Response to Urban Design Peer Review by Lisa Mein Prepared by Studio Pacific Architecture Ltd

20th November 2025

This memo has been prepared by Studio Pacific Architecture Ltd in response to the urban design comments raised by Lisa Mein in her peer review of the Sunfield masterplan. It addresses the matters we consider most relevant to achieving high-quality urban design outcomes for Sunfield and the wider surrounding communities.

2.3 Sunfield is integrated with the rapid transit network

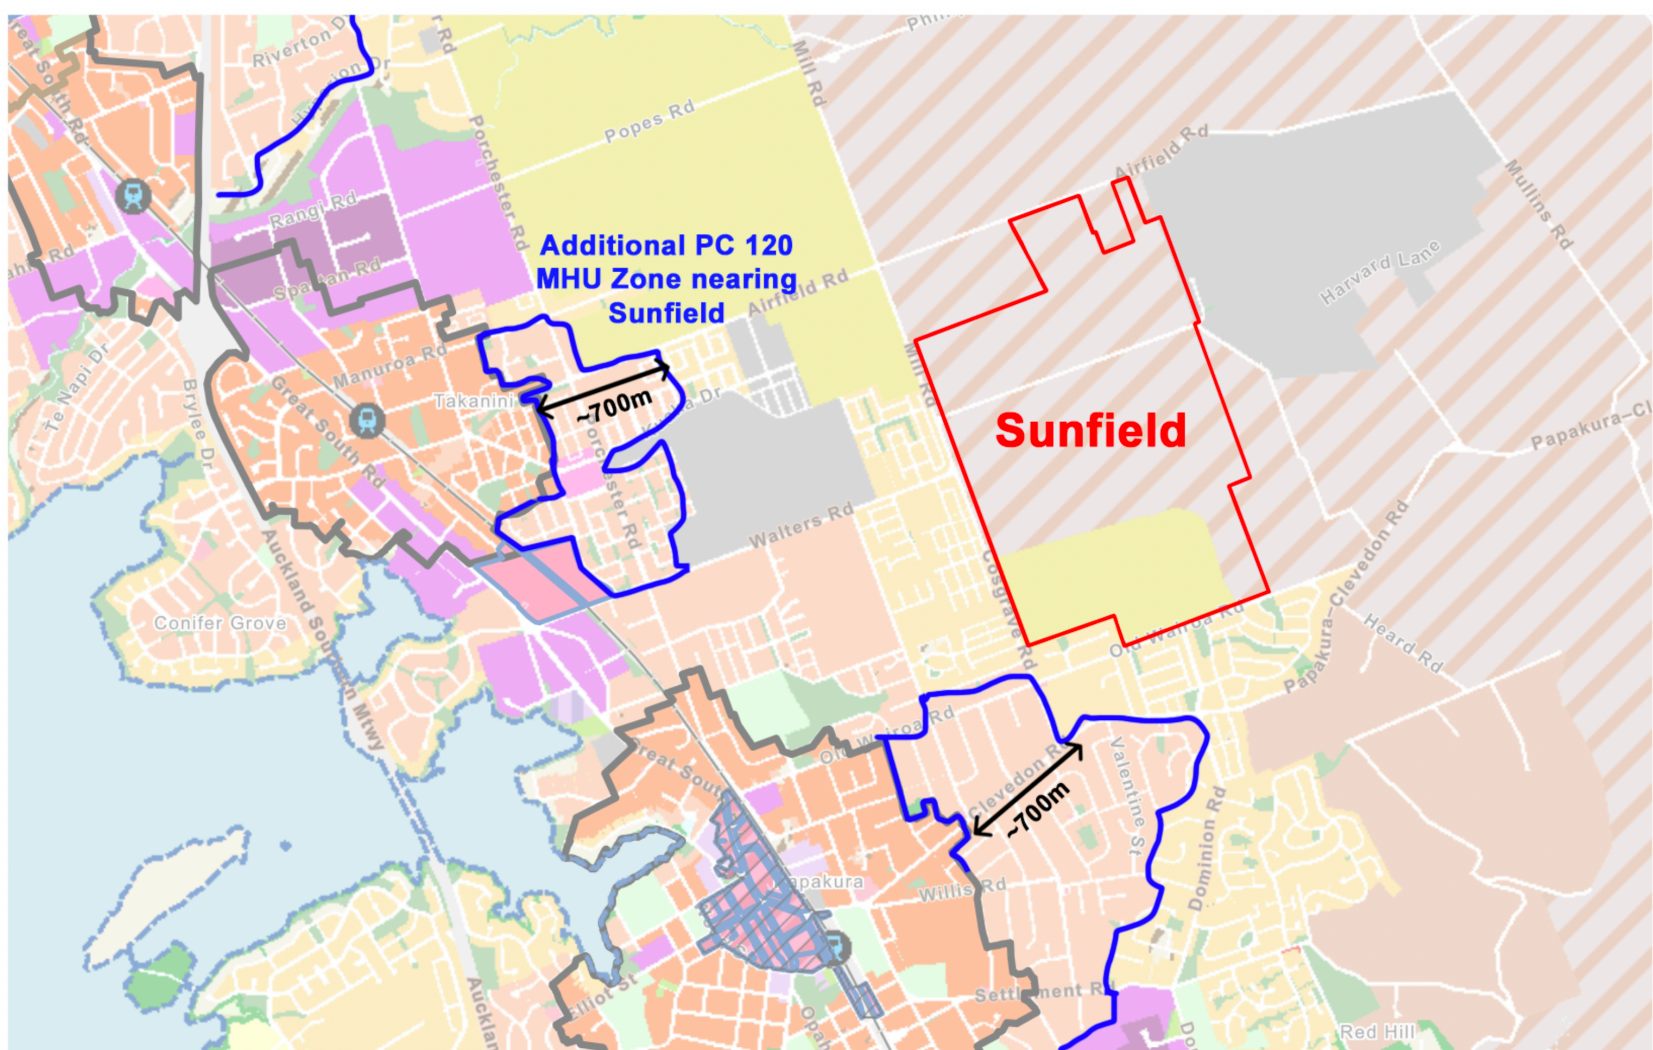
In the conclusion of her peer review Ms Mein notes that Sunfield has “*relatively poor connection to rapid transit*”. This is simply not true, and we fundamentally disagree with this statement:

- Sunfield has excellent public transport access. The Sunfield Loop is designed intentionally to provide a frequent bus service to all residential neighbourhoods.
- As such, and similarly with the case-studies we’ve provided, Sunfield residents will have direct public transport bus connections to the Southern Line rail network.
- Sunfield has cycling connections that would enable 5-10 minute trips by e-bike, e-scooter, or a touch more by bike. Cycling to the rail stations are acknowledged by Ms Mein as a viable transport option for Sunfield.
- A series of upgrades are proposed to provide a greater level of service to local transport hubs.

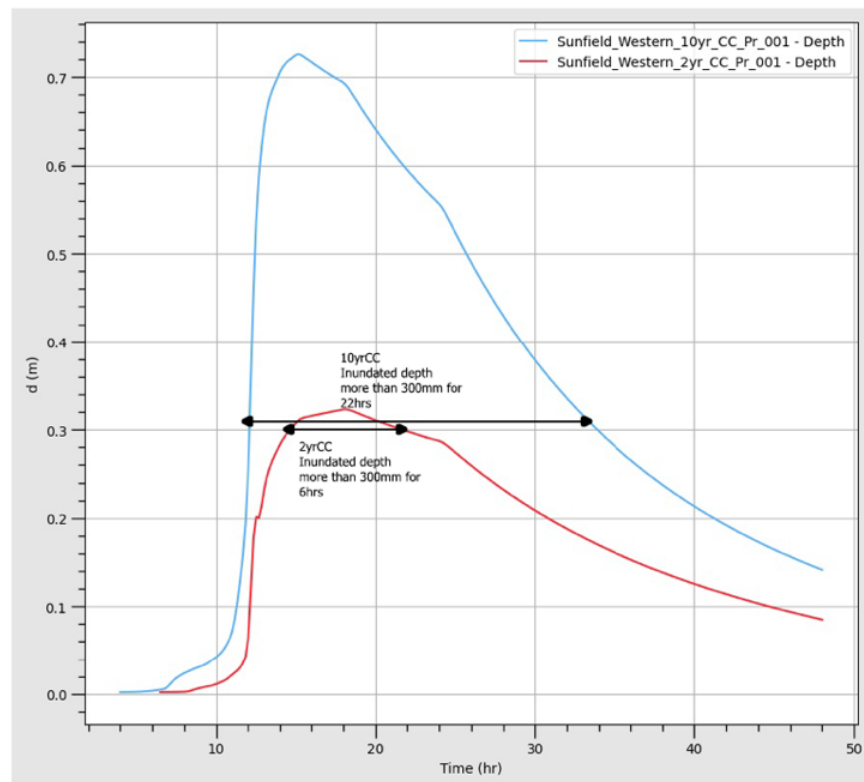
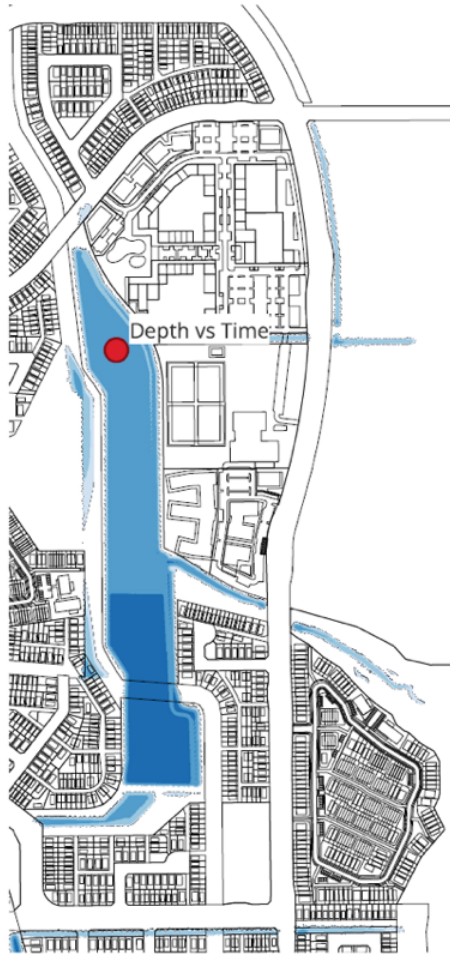
In section 2.7 of her peer review Ms Mein notes that the Council is seeking four flood-free neighbourhood parks, supported by a central suburb park, all integrated with the street network. She then notes that in response to the Council's extensive comments the applicant has offered an updated open space strategy. However, she then goes on to say that *'no additional neighbourhood parks are proposed nor have the locations of the proposed parks been amended, with the exception of one on the eastern side which has been both relocated and reduced in scale.'*

The updated open space strategy provided by the applicant does in fact provide 3 additional 0.1ha neighbourhood parks in line with the proposed distribution plan provided by Council. The updated open space strategy provides 4 neighbourhood parks within the residential neighbourhoods to provide greater accessibility to flood-free play for residents and that comfortably provide for all of the functional amenity required of a neighbourhood park, specifically that they include a level, unobstructed grass space for informal games of at least 20m x 20m in parks less than 0.3ha in size.

- **Open Space Distribution Plan** that responds to Council's suggestions to include additional neighbourhood parks, and improve the park distribution.
- **Open Space Areas Plan** which highlights the 53Ha of blue/green networks totalling ~21% of the Sunfield site area.
- **Open Space Flooding 10 Year Event Plan** which show a revised park layout that responds more resiliently to the 10 year flood event.
